BUILDING CODE OF AUSTRALIA Audit Report

126 Watt Road, MORNINGTON

McKenzie Group Consulting (Vic) Pty Ltd
ACN 093 211 977
Level 2, 99 William Street
Melbourne VIC 3000

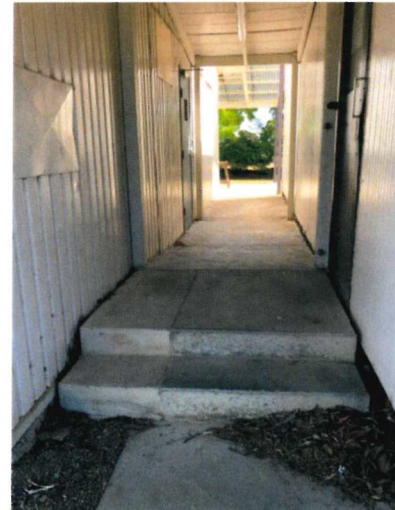
12. Steps to front entrance of portables contains stairs with non-compliant handrails and tactiles and non-consistence going and risers.
